UNITED STATES PATENT AND TRADEMARK OFFICE

10/675,206

Office Action Summary	Application No.	Applicant(s)	
	10/675,206	ONDE ET AL.	
	Examiner	Art Unit	
	Hanh Phan	2613

DETAILED ACTION

Fig. 3
Prior Art

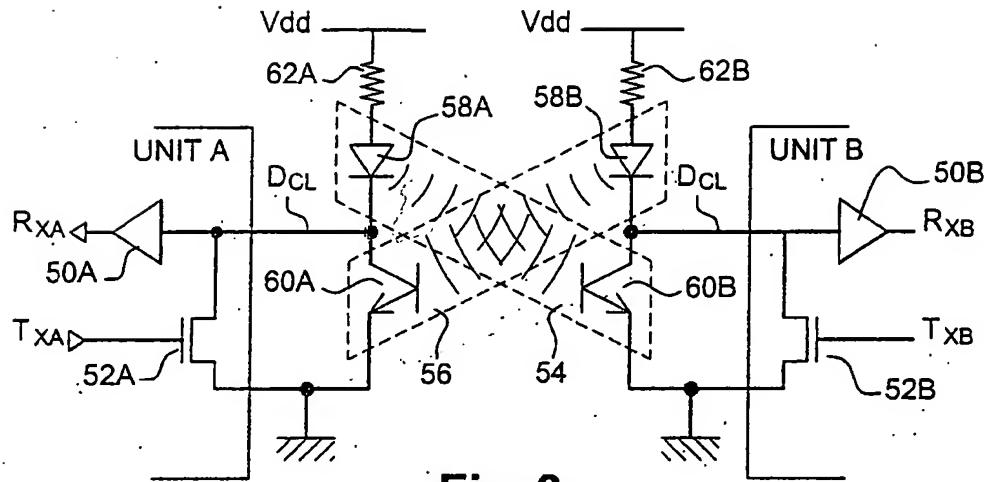
5. Claims 1, 14-17 and 26 are rejected under 35 U.S.C. 103(a) as being unpatentable over Prior Art Figure 3 in view of Riley (US Patent No. 6,750,463).

Regarding claims 1 and 17, Prior Art Figure 3 teaches an optical coupling device operative over a bidirectional data link between at least first and second communicating units (i.e., first communicating unit A and second communicating unit B), each operative to send and receive data along a common wire of the data transmission link, the device comprising:

at least first and second optical coupling means (i.e., a first optical coupling means comprises a photon flux source 58A and a photon flux detector 60A and a second optical coupling means comprises a photon flux source 58B and a photon flux detector 60B), each comprising a photon flux source and a photon flux detector, wherein:

the photon flux source of the first optical coupling means (i.e., LED 58 A) is commanded in response to a data transmission by the first communicating unit, the photon flux source of the second optical coupling means (i.e., LED 58B) is commanded in response to a data transmission by the second communicating unit,

the photon flux detector of the first optical coupling means (i.e., photo flux detector 60A) is operative to produce a signal on the data transmission link at the first communicating unit in response to a command of the photon flux source of the second optical coupling means from the second communicating unit,

the photon flux detector of the second optical coupling means (i.e., photon flux detector 60B) is operative to produce a signal on the data link at the second communicating unit in response to a command of the photon flux source of the first optical coupling means from the first communicating unit.

The Prior Art Figure 3 differs from claims 1 and 17 in that it fails to teach first inhibiting means for inhibiting the photon flux source of the second optical coupling means in response to an activation of the photon flux source of the first optical coupling means, and second inhibiting means for inhibiting the photon flux source of the first optical coupling means in response to an activation of the photon flux source of the second optical coupling means. Riley, from the same filed of endeavor likewise teaches an optical isolation device (Figures 2-4). Riley further teaches first inhibiting means for inhibiting the photon flux source of the second optical coupling means in response to an activation of the photon flux source of the first optical coupling means, and second inhibiting means for inhibiting the photon flux source of the first optical coupling means
